MEMORANDUM

From:	Built Heritage Officer	Service:	Green Infrastructure
Application No.	252192	Site Visit Made:	Previously
Address:	Moat House, Biggs Lane, Arborfield, RG2 9LN.

Proposal:	Application for submission of details to comply with the following conditions of planning consent 242252 and those of listed building consent 242253 , dated 21/02/2025. Condition 3 relates to building recording; 4 to detailed drawings (strip-out/removal works); 5 to thermal insulation, noise and fire protection between flats; 6 to secondary glazing details; 11 to original room doors and door surrounds; 12 to joinery details (windows/doors); 17 to entrance intercom/ entry system; 18 to highway construction details; 20 to cycle parking; 21 to bin storage; 22 to boundary treatment, and 23 a Landscape Scheme.
------------------	---

Extract from drawing 16-003 Rev. C4: Superstructure Details

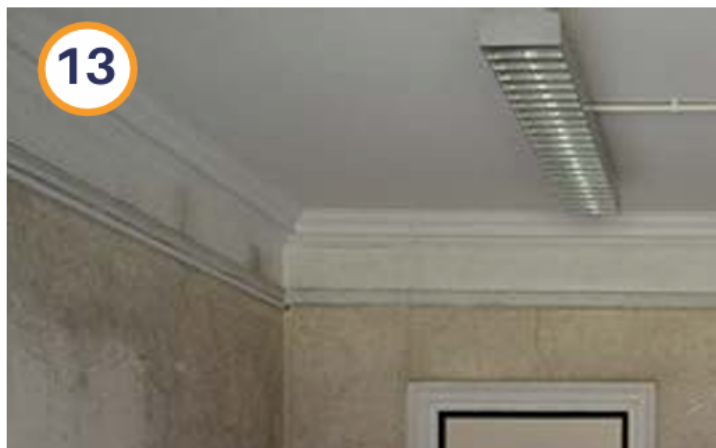
The two areas requiring confirmation concern the retention of the original architrave detailing to the ceilings of the ground and first floor. Whilst the section images for the ground floor and first floor ceilings show in drawing 16-003 Rev. C4: Superstructure Details, show the ceiling architrave boxed in, and contained with new false ceiling, these details only show this with respect to the external walling external walling. Need confirmation the boxing in of the architrave would be to all sides of the room and around the fireplaces, and internal masonry walls.

Extract from drawing 16-004 Rev. C3

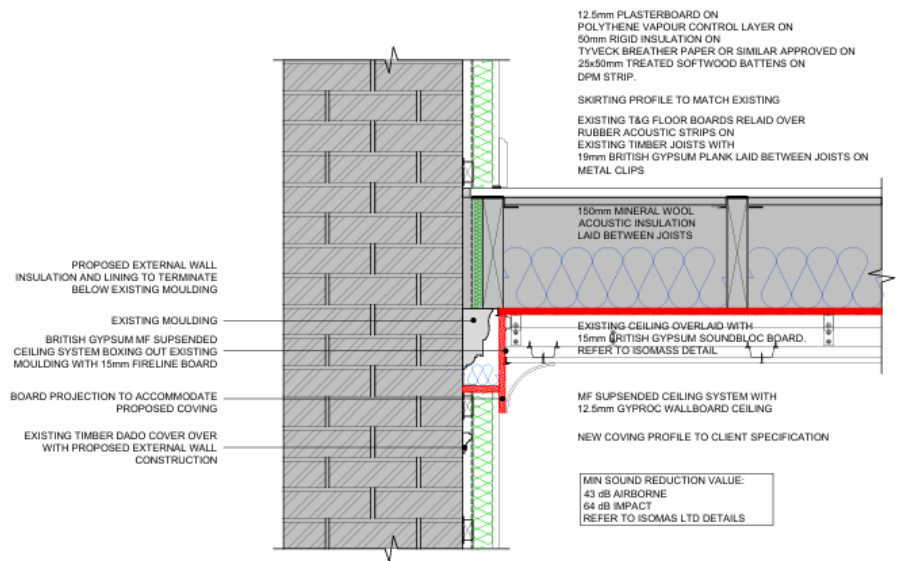
In the case of drawing 16-004 Rev. C3: Cill, Head and Reveal Details this confirms that along with no insulation will be introduced to the reveals of those windows where secondary glazing units are to be fitted. Furthermore, the installation of the secondary glazing units is to be undertaken in a manner that now retain unaltered the original window cills.

With respect to the intended window bulkhead for the living room window (F8) of Apartment 3 on the section drawing (16-004 Rev. C3) does not appear to show the retention of the historic architrave that is presumed to exist and is expected to be retained.

Extract of Section E-E from drawing 13-001 Rev. C3

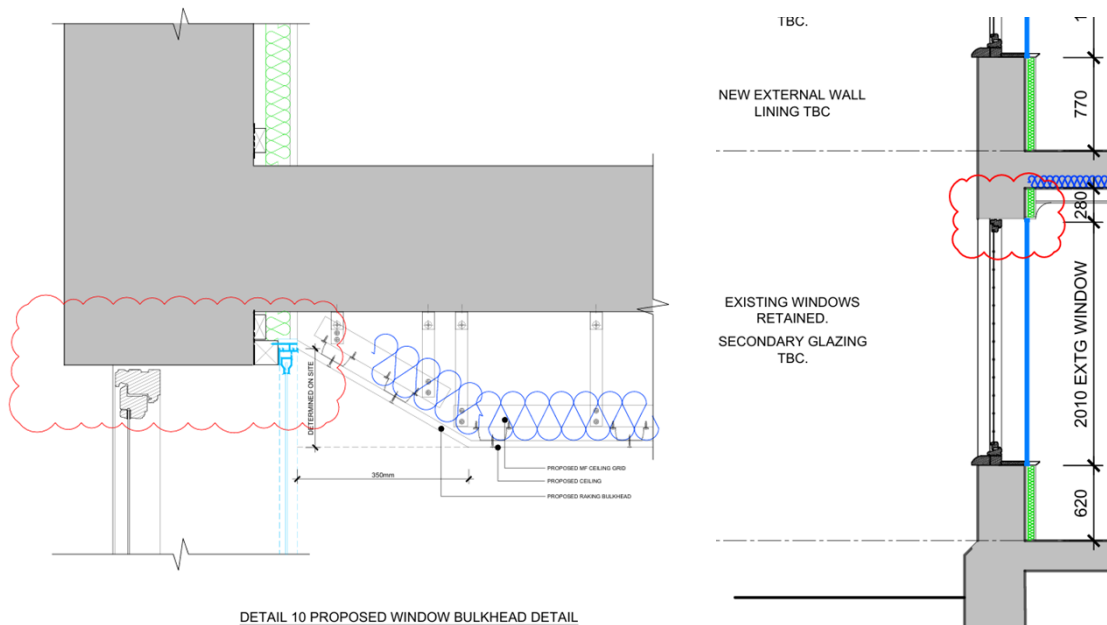
Also, with respect to drawing 13-001 Rev. C3: Sections and this may be down to purley the scale of the drawing, which do not appear to show the window cills being retained, whilst with the intended new /false ceilings of the ground and first floor the boxing in of the architrave is not shown loor ceilings as shown but rather a layer of insulation to the walls right up to the existing ceilings.
